MEMORANDUM

RE: 375 DESCHÂTELETS AVENUE - SITE PLAN CONTROL
RUNOFF COEFFICIENT CALCULATION OF AREAS ABOVE
UNDERGROUND PARKING ROOF SLAB
NOVATECH PROJECT #: 114025

Figure 1. Phase III PCSWMM Model Subcatchments

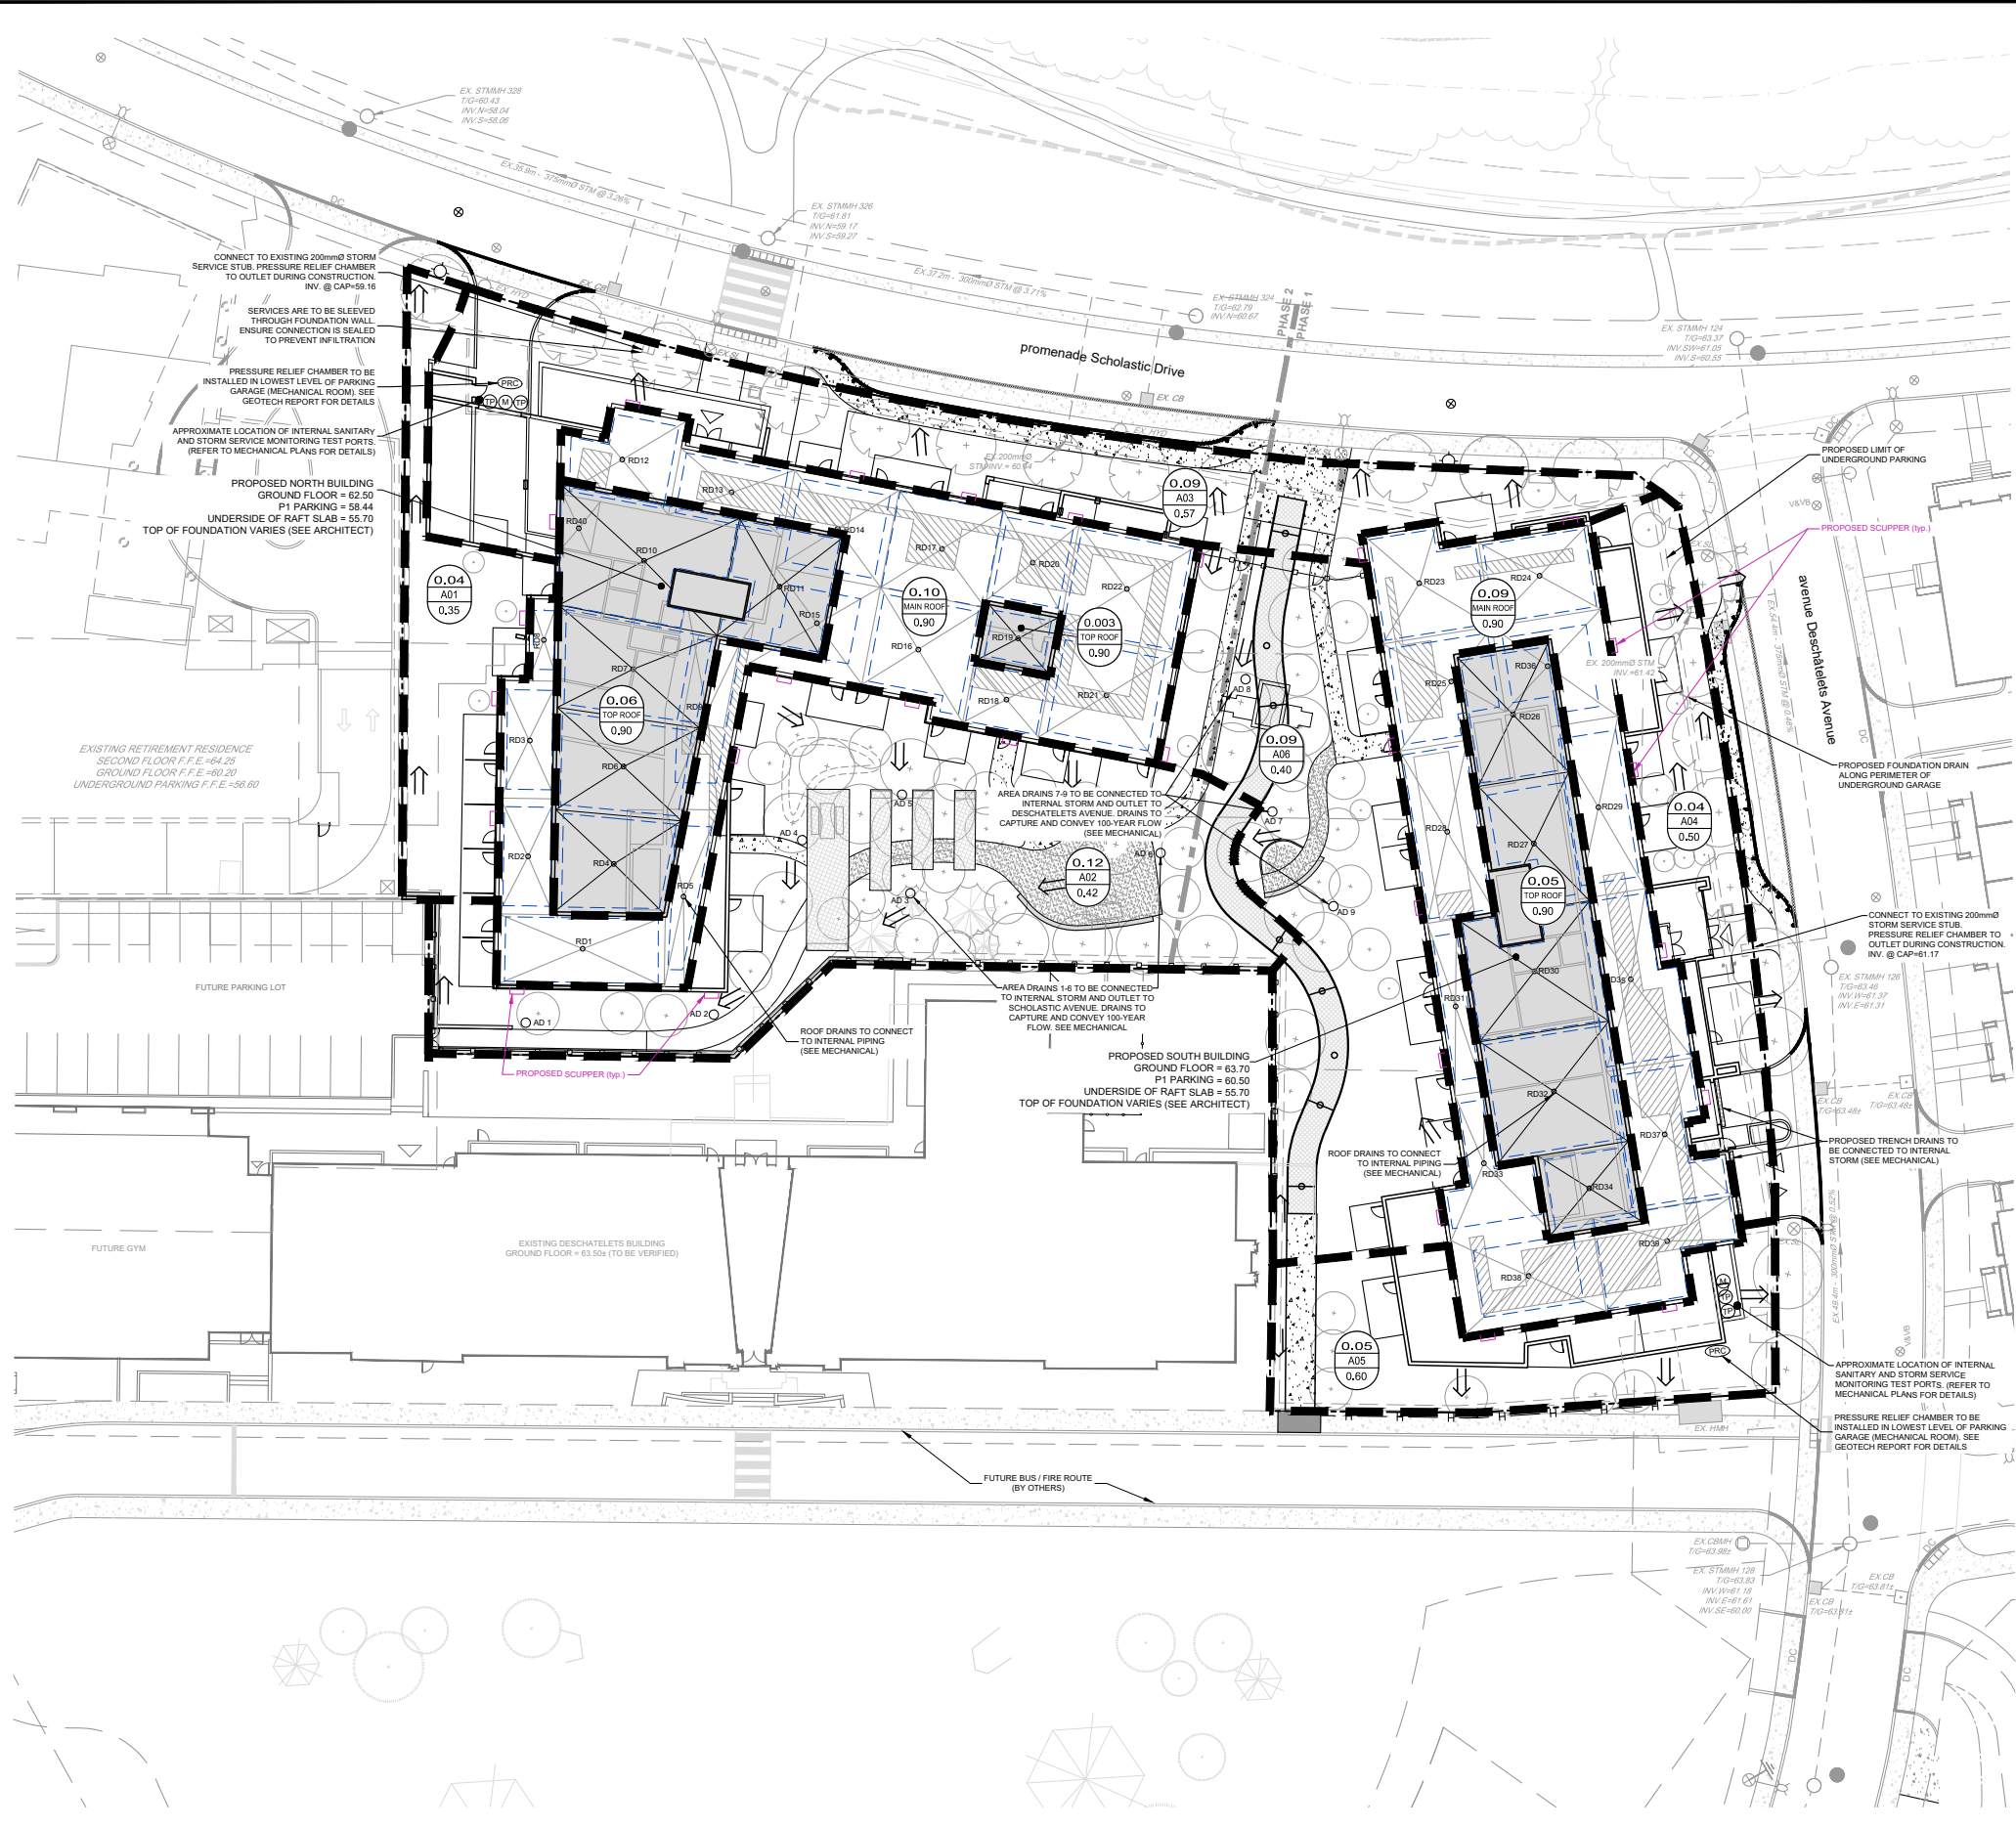
“Area A01, A02, A03, A04, A05, and A06 are above the underground parking roof slab. Storm water collected in this area during a major event will eventually drain to the City System. Runoff Coefficient and release rate calculations provided for this area are incorrect.

The soil above the underground parking will act as storage layer above the impermeable Roof Slab with 100-year C value of 1. Please revise the calculations. Provide discussions on what will be the available storage volume and release rate from this layer. Please include discussions from geotechnical engineer about the available storage volume and release rates”

The PCSWMM model currently represents these subcatchments as pervious areas using standard City of Ottawa runoff coefficients and infiltration parameters, in which a portion of the rainfall is infiltrated into the the soil above the parking garage roof slab, any excess storm runoff is conveyed overland to storm inlets to the storm sewer system in Scholastic Drive and Deschâtelets Avenue. Based on the proposed grading and architectural plans, there is a significant depth of soil above the top of the roof slabs. Water percolating through the soil column will eventually reach the roof slab where it will be collected by perforated pipes, or flow laterally to the outer edge of the slab where it will continue to percolate downwards.

Upon further review of the hydrology for these catchments and discussions with the Geotechnical engineer for the project, we have determined that the modeling approach used is appropriate. This memo has been prepared in support of the hydrologic analysis and provides additional information on soil storage volumes and release rates.

PCSWMM is used to model the proposed stormwater management for the Phase III site application. **Figure 1** illustrates the subcatchment areas used in the PCSWMM model. The hydrologic parameters for each subcatchment were developed based on the proposed land use and grading.
